NTD-NRC-94-4075
DCP/NRC0014
Docket No.: STN-52-003

SUBJECT: WESTINGHOUSE RESPONSES TO NRC REQUESTS FOR ADDITIONAL
INFORMATION ON THE AP600

NTD-NRC-94-4075
ATTACHMENT A
AP600 RAI RESPONSES
SUBMITTED MARCH 4, 1994

Figure 1-1
AP600 LONF ATWS: Base Case
Nuclear Power

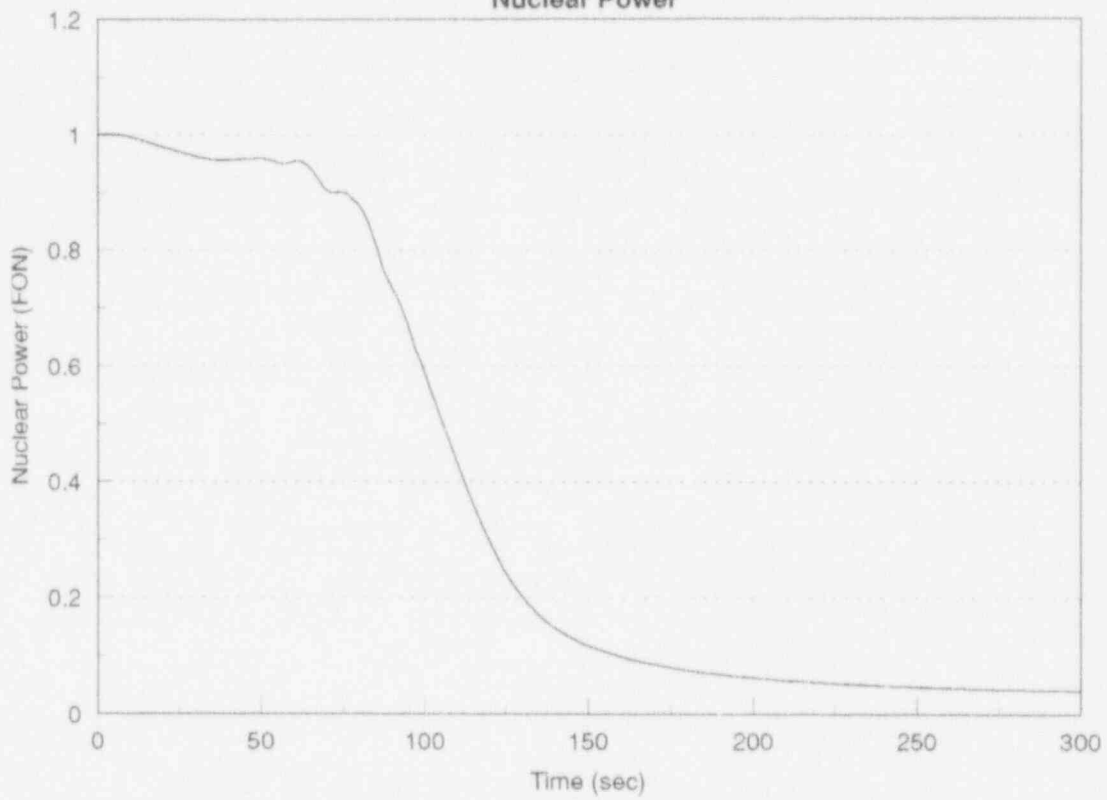
Section 15.8 of the SSAR states that AP600 plant design includes a diverse actuation system, which provides for all of the AMSAC protection features mandated for Westinghouse plants plus a diverse reactor scram, and thus meets the ATWS rule. However, it does not provide an ATWS analysis to demonstrate that AP600 ATWS response is consistent with that considered by the staff in its formulation of the 10 CFR 50.62 design requirements for current plants. Provide such an analysis.

The nuclear power transient is presented in Figure 1-1. As the reactor coolant system heatup proceeds, the negative moderator density coefficient produces a decrease in reactor power. The core power falls to a value below the rate of passive residual heat removal as shown in Figure 1-2. Eventually, core power reaches an equilibrium dictated by the combined heat removal capability of the passive residual heat removal system and the steam generators.
